864-872 King St W proposed development

Comments on 864-876 King Street West

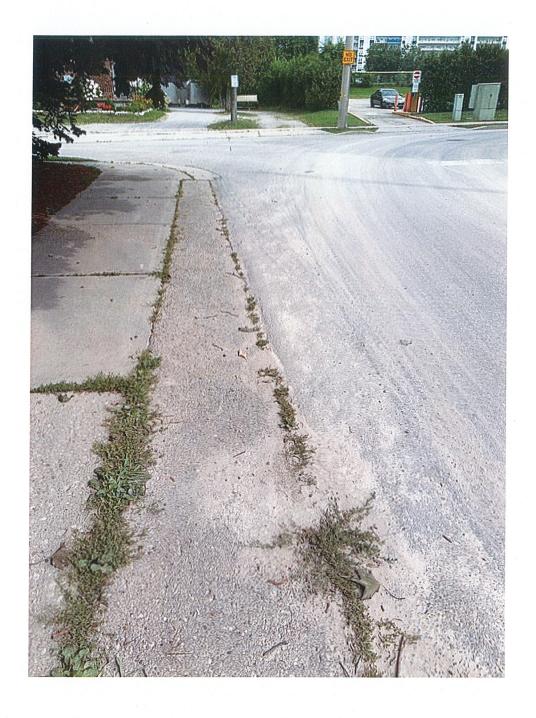
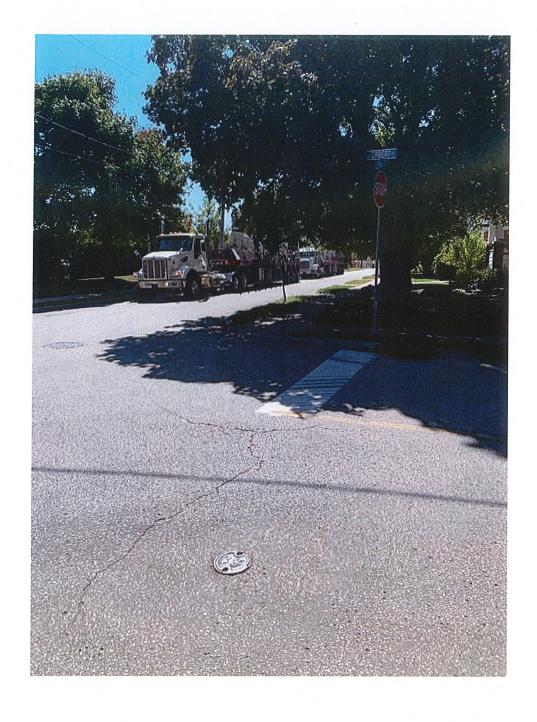
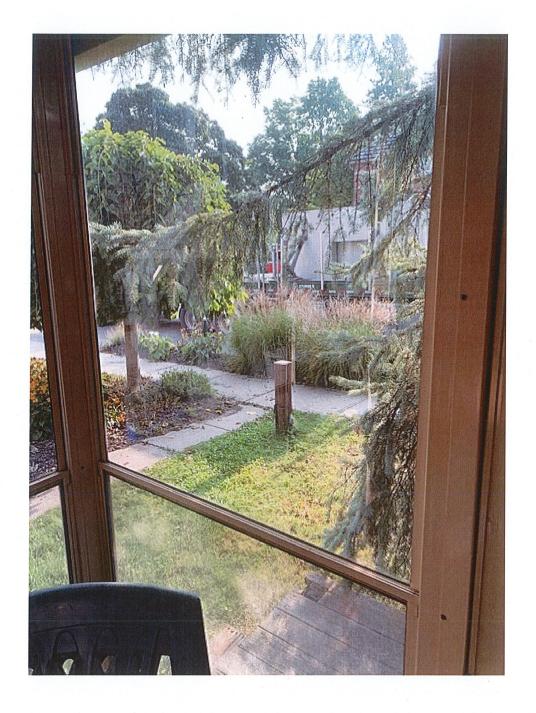
My wife and I live at Kitchener, v treet (refer to attached photo's). In other words, we are located at ground zero. All the heavy construction equipment comes up Herbert Street from Union. These trucks then pull forward into the dead end of Pine Street, then they back up Pine Street all the way to King Street, with the annoying and very loud backup beeping. Our upstair bedroom window faces the dead end of Pine Street (refer to attached photo's and video of heavy equipment truck idling outside our sun porch - sometimes idling for 15-20 minutes). The truck and trailer lengths of this equipment makes it almost impossible to negioate their turns at Herbert and Pine, which has resulted in some of our tree branches being broken.

- 1. What route will all the heavy construction vehicles take if this tower is approved? Herbert Street and Pine Street again? Clearly, this cannot happen again!
- 2. How is the traffic congestion of new vehicular traffic being addressed? Clearly Pine Street, Mary Street and more so Herbert Street, will be endless traffic now.
- 3. What is the exact time frame for Herbert Street to be repaired and re-paved? It cannot be changed as it is overdue now.
- 4. Has any financial compensation been considered for affected residents in regards to the current tower under construction or for the proposed additional tower? the legal term would be "interfering with the lawful enjoyment of one's property".
